F RSTECH, LLC. SUPPORT - 1(888) 820-3690, EXT. 203

Overview: The initial production release of the FTI-TLK1 harness has an issue where in some vehicles the secondary power input to the CN1 connector will overload the associated vehicle circuit, causing a fuse to blow. This issue affects the initial release of harnesses and is already being addressed in production. A field correction procedure is detailed below in Figure 1.

FTI-TLK1 Type 3B4 - Vehicle Coverage & Preparation Notes

Figure 1: Step by step adapter correction

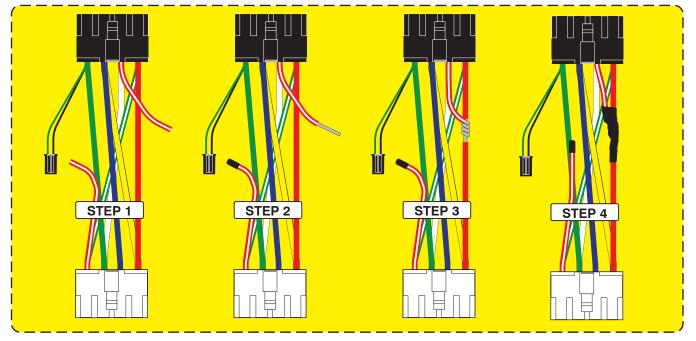
Issue: The secondary power circuit can overload some vehicle ignition switch circuits, causing a blown 5A/7.5A AM1 fuse, potentially disabling the vehicle and leaving the consumer stranded. Affected adapters are illustrated below in figure 2.

- 1.) Select the applicable CN1 adapter, isolate the RED/WHITE power wire, cut wire approximately 4" from the BLACK plug
- 2.) Insulate the wire still connected to the WHITE plug using heat shrink tubing, and strip the insulation on the other wire end
- 3.) Strip a portion of the insulation from the RED wire, attach the stripped RED/WHITE to the exposed RED wire, solder together
- 4.) Apply insulating tape to the soldered connection and secure the cut ends back to the bundle of wires created by the adapter
- 5.) Correction complete, you may safely proceed to finish your installation
